RE: NORTH BYRON PARKLANDS SOUTH EAST CARPARK STORMWATER DISCHARGE STRATEGY

State Significant Development Application Ref SSD 8169

RE: PROPOSED STORMWATER MANAGEMENT STRATEGY FOR THE SOUTHEAST PARKING AREA PROPOSED AS PART OF THE NORTH BYRON PARKLANDS CULTURAL EVENTS DEVELOPMENT

SECTION A
SCALE 1:100
P-08

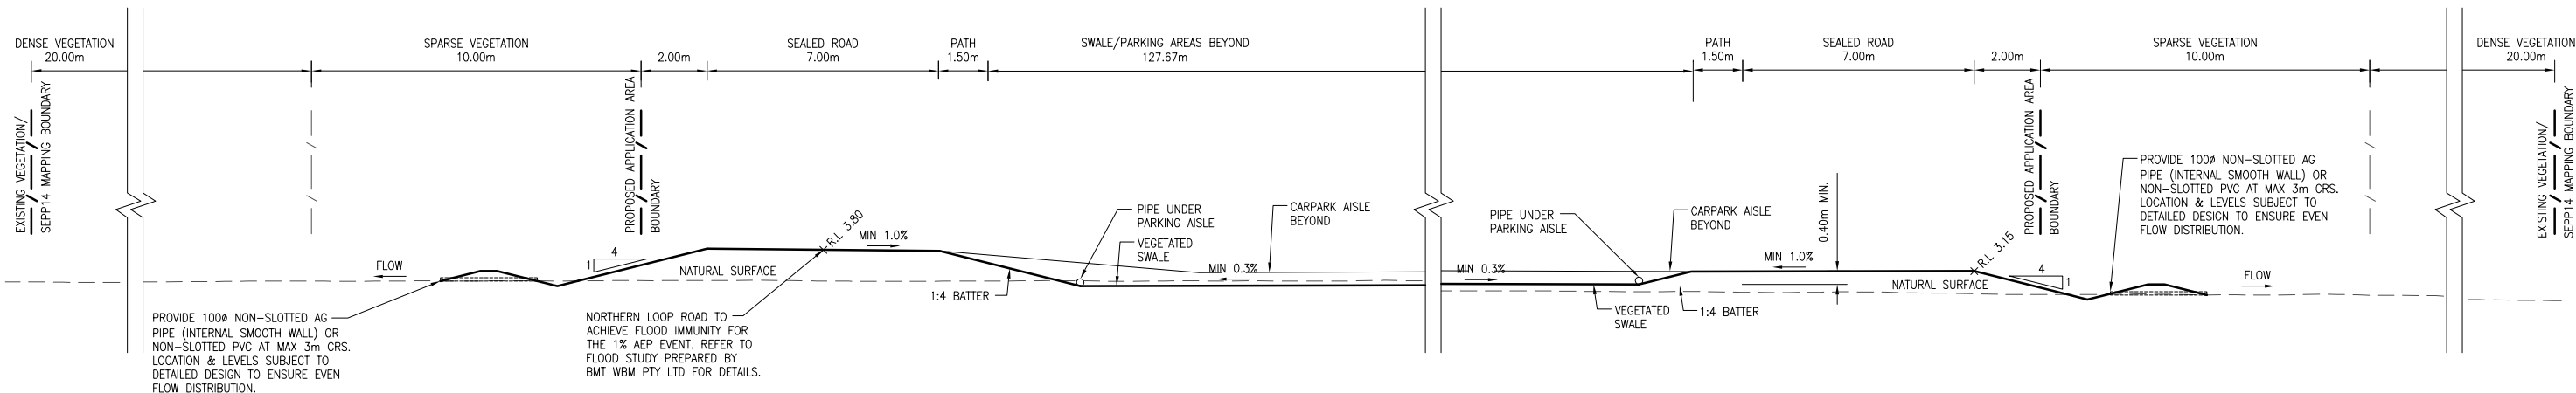
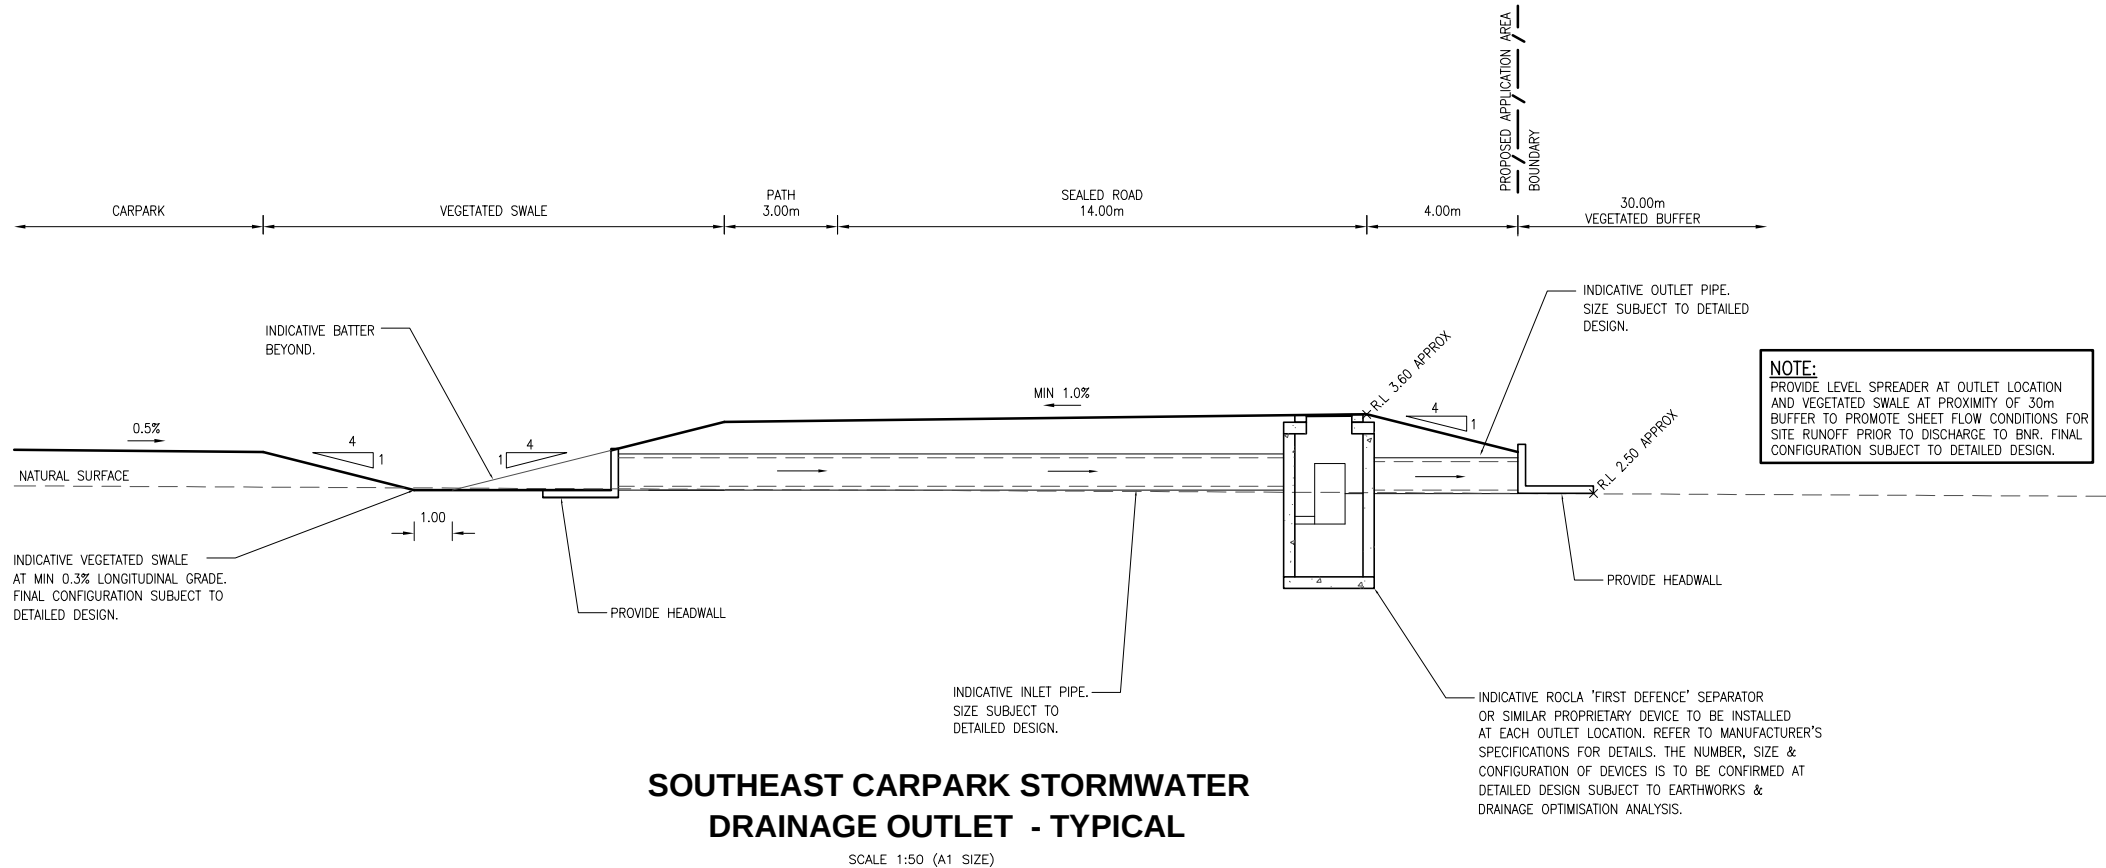
The existing topography is generally quite flat without significantly concentrated flow channels. Therefore the proposed works will need to ensure the stormwater from the carpark area is returned to sheet flow in accordance with existing conditions. The concept plans indicate potentially three concentrated outfall points along the northern loop road and three along the southern loop road. These outfall points are only proposed for the minor storm events to obtain treatment through the SQUIDS located at each piped culvert under the loop road. Flows in excess of the SQUID treatment flow may discharge over the loop road at various low points along the loop road and at the culvert locations subject to detailed design. Irrespective of the outfall locations (minor or major storm), the flow paths will need to be linked and return to sheet flow before discharging off site. This shall be achieved through incorporating a level spreader swale and bund on the downslope side of the loop road as shown in Figure 2.

No.	DATE	REVISIONS
A	29.06.2018	SECTION A ADDED

APPROVED	DESIGNED S.J.I.	SHEET NUMBER
	DRAWN J.H.C.	8 OF 21
	DATE DRAWN FEBRUARY 2017	REVISION C
	FILE NAME Pre_CivilWks_P1.dwg	PROJECT NUMBER B17/016 P

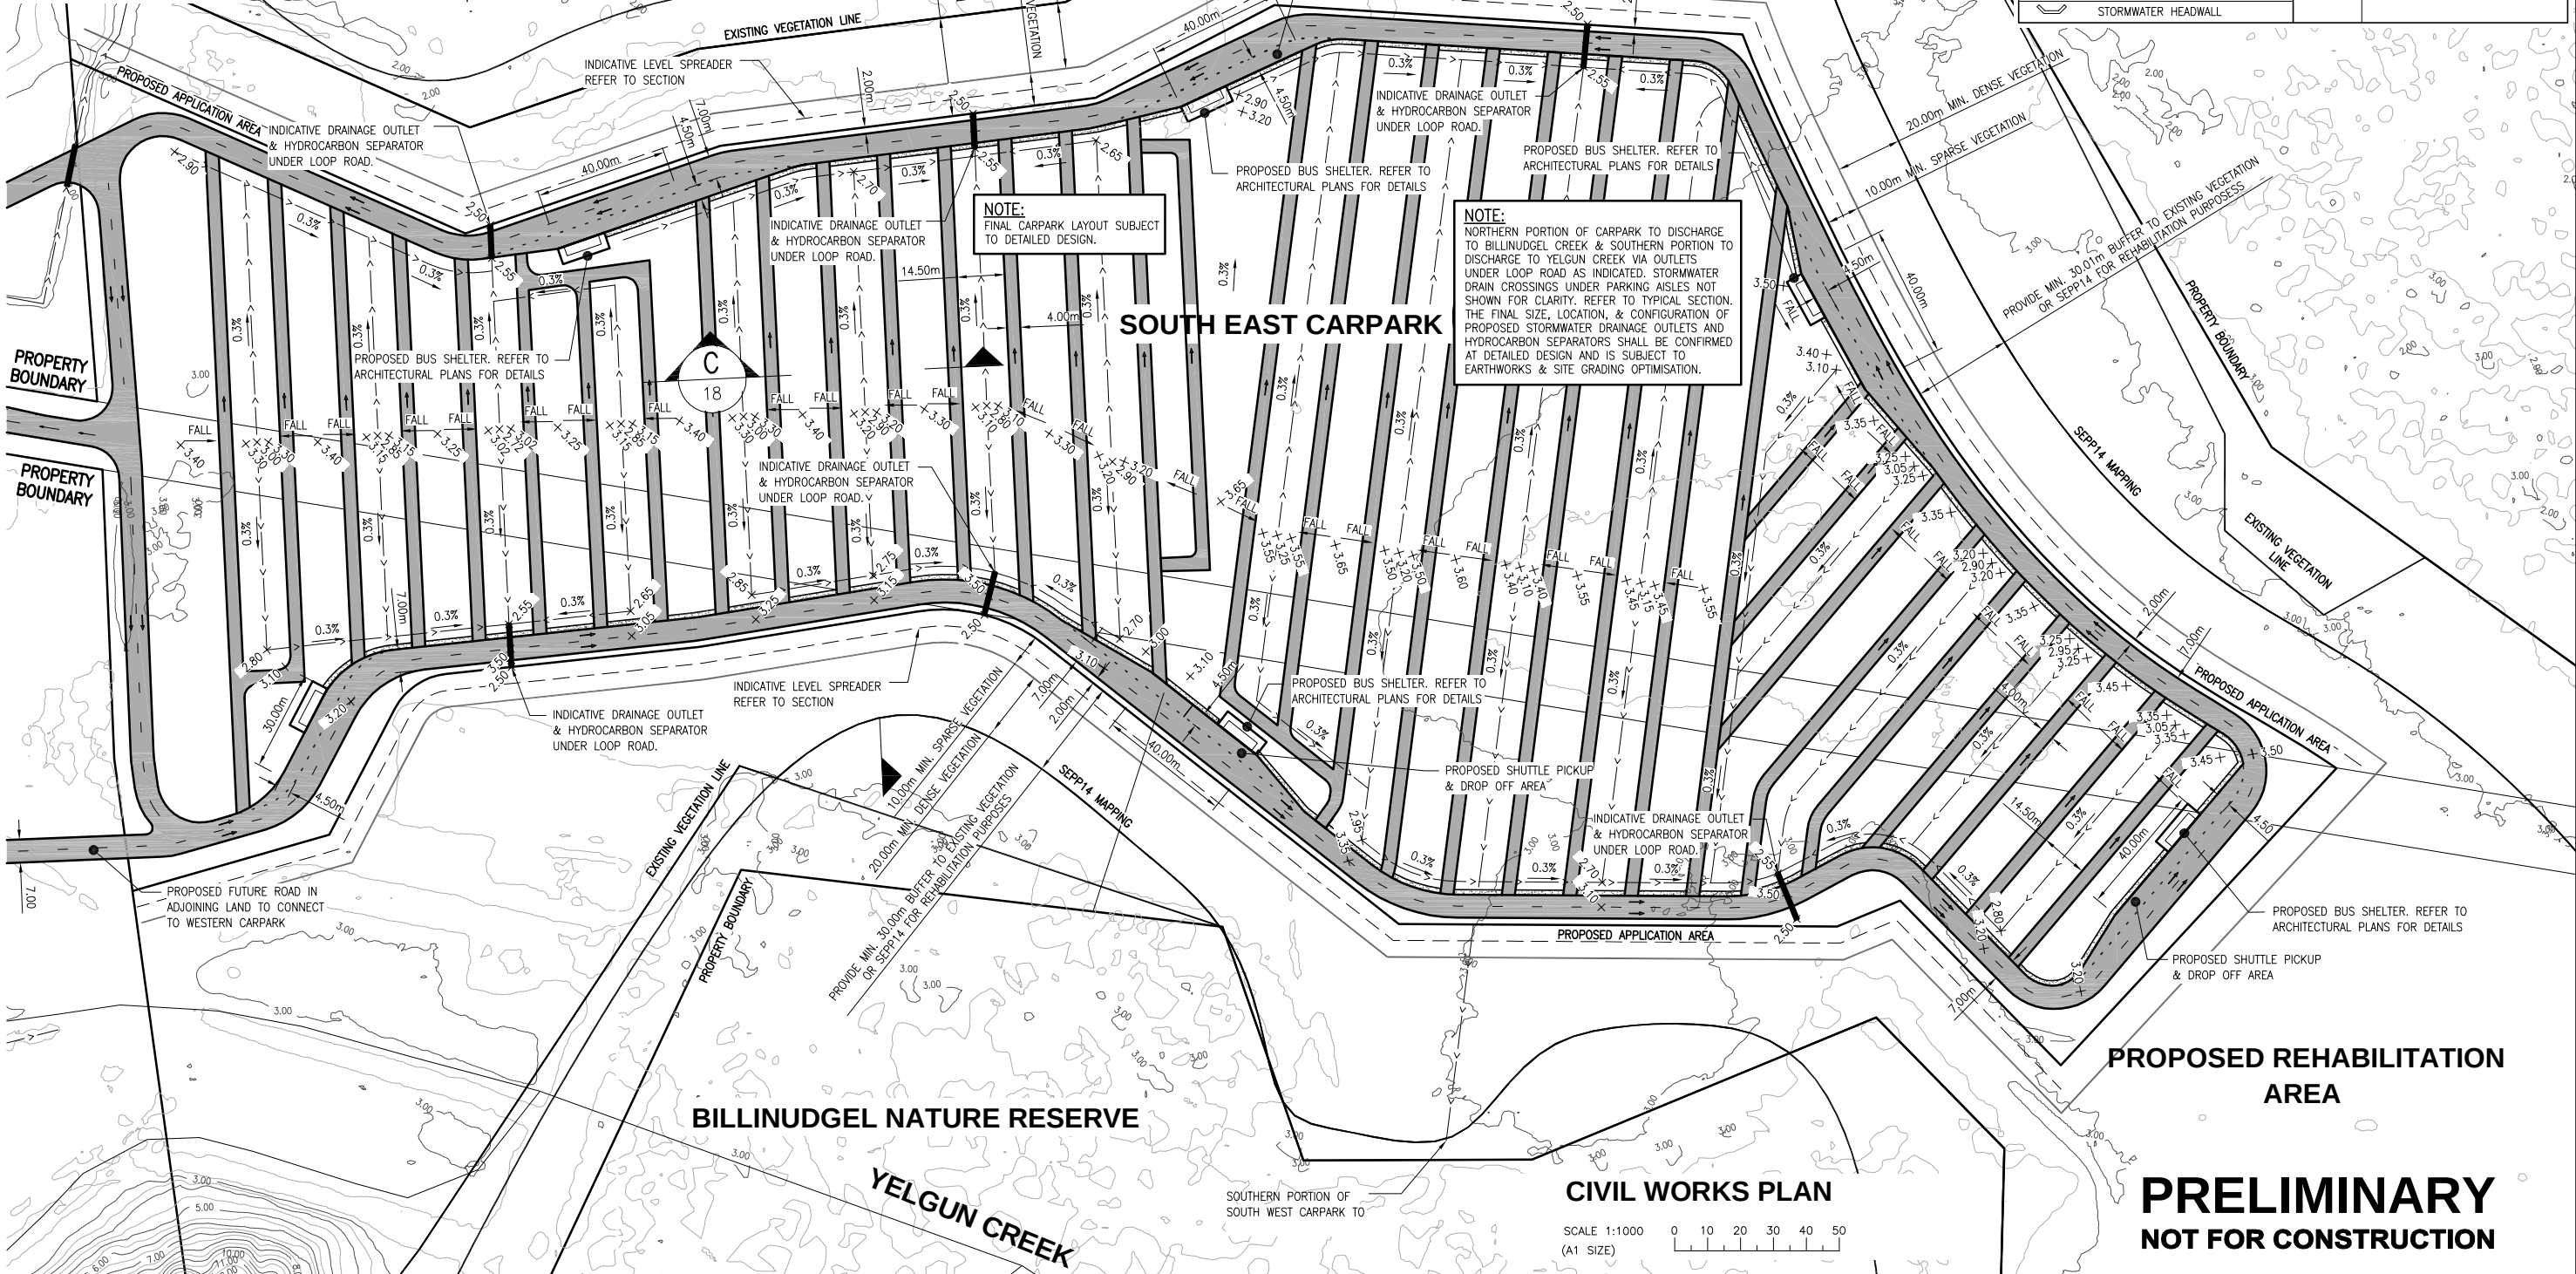
The concept engineering drawing B17/016 P 08 Revision C has been amended to show the indicative levels and proposed level spreader and is attached to this letter for reference.

DATUM	No.	DATE	REVISIONS
LIDAR			
	C	29.06.2018	LEVELS ADDED TO PLAN
	B	15.05.2018	STORMWATER DRAINAGE AMENDED & VEGETATION SETBACK ADDED
	A	16.11.2017	LOT NUMBERS & SOUTHEAST CARPARK AMENDED
